REFERENCE: 22-24 RAGLAN STREET, MANLY NSW 2095

RESIDENTIAL FLAT BUILDING

BUILDING CODE OF AUSTRALIA (BCA) CAPABILITY STATEMENT

Figure 2 – Ground Floor Plan - (Source: Carlisle Architects)

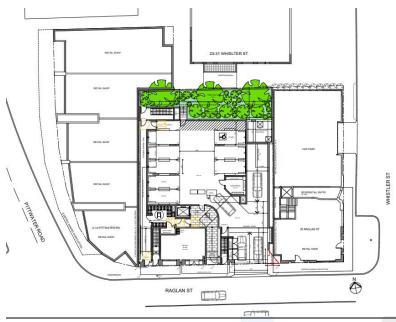
- a) <u>Ground Floor</u> The opening in the vertical plane between building elements along the vehicular driveway is located within 3m of the Eastern allotment Boundary;

- (a) <u>Basement Level</u> The space between the Basement Stair 2 and the Northern Elevation external wall is less than 1.0m and access to this space will either need to be restricted or addressed via a performance based solution:
- (b) <u>Basement Level -</u> The storage cages in the basement (i.e. units 6 & 13) are less than 1.0m in width and will either need to be increased to a minimum of 1.0m or addressed via performance based solution;
- (c) <u>Basement Level</u> There may be reduced egress widths around pumps and plant equipment in lieu of minimum 1.0m required in the plant rooms and where this occurs, this will need to be addressed via a performance based solution;
- (d) <u>Ground Floor</u>– The stair providing access to the rear landscaped area will need to be provided with a handrail and this may reduce egress widths to be less than the minimum 1.0m required.

- a) <u>Fire Brigade Booster Assembly</u> -The location of the Booster Assembly is considered to be within the building and not the façade, the valves do not face the street as required by AS2419.1-2021 and this booster location and arrangement will need to be addressed via a Performance based solution.
- b) <u>Hydrant Landing Valve Locations</u> Hydrants are to be located on each storey and installed within the fire stairs ensuring egress paths are not reduced to under 1.0m unless otherwise addressed via a Performance Based Solution;
- c) <u>Coverage Plans</u> Fire Hydrant Sweep diagrams are to be provided to confirm coverage throughout at the Construction Certificate Stage;
- d) <u>Design Departures</u> The fire services engineers are to identify any shortfalls or departures associated with the either the BCA or the relevant Australian Standards;

- a) <u>Fire Hose Reel Coverage</u> Fire Hose Reel coverage is required to all areas of the basement level & Ground Floor level (including services plant room, and waste room) without passing through fire doors.
- b) <u>Fire Hose Reel Coverage Plans</u> Detailed sweep coverage plans with dimensions are to accompany the Construction Certificate application.
- c) <u>Fire Hose Reel Design Departures</u> Any departures associated with the systems Standard of Performance (AS2441.1-2005) needs to be identified by the Registered Design Practitioner/Competent Fire Safety Practitioner for the Registered Certifier and Fire Safety Engineers consideration.
